YANKEE ATOMIC ELECTRIC COMPANY

WYR 78-100

Subject: Core XIV Refueling

PROPOSED CHANGE:

Figure 3.2.1

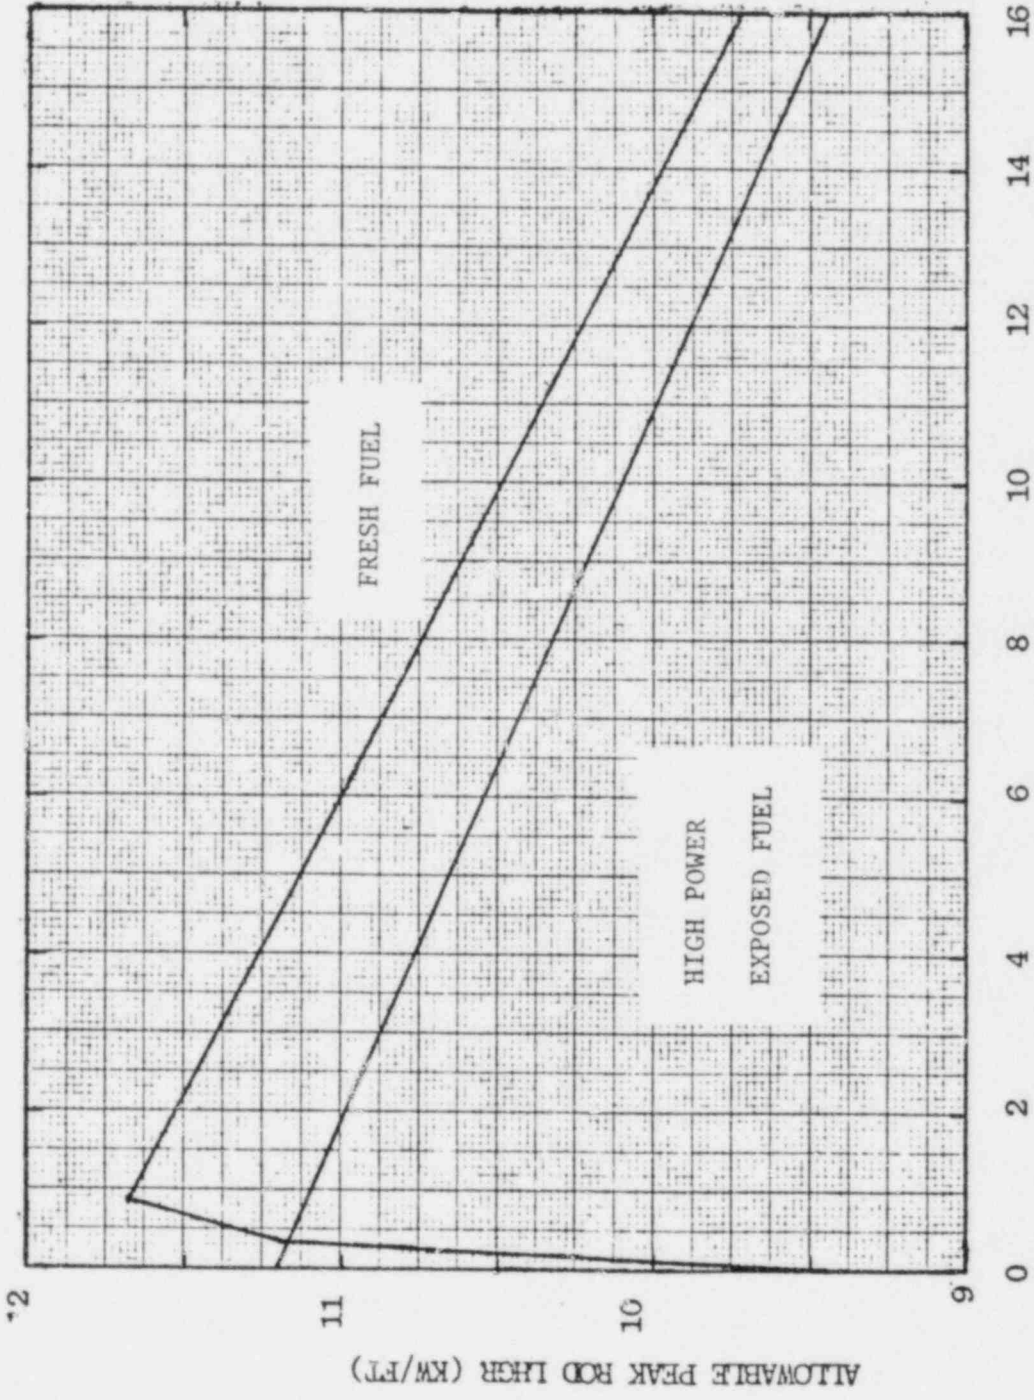
1. Modify Figure 3.2.1 of the Technical Specifications as specified on the attached page.

The modification to Figure 3.2.1 of the Technical Specifications is to add an additional limit on the Allowable Peak Rod Linear Heat Generation Rate. The added limit is for the recycled fuel from Core XIII which will have the highest linear heat generation rate during Core XIV (called high power exposed fuel). This additional limit will assure plant operation within the limits defined by the LOCA analyses discussed in Reference (b) for the recycled fuel.
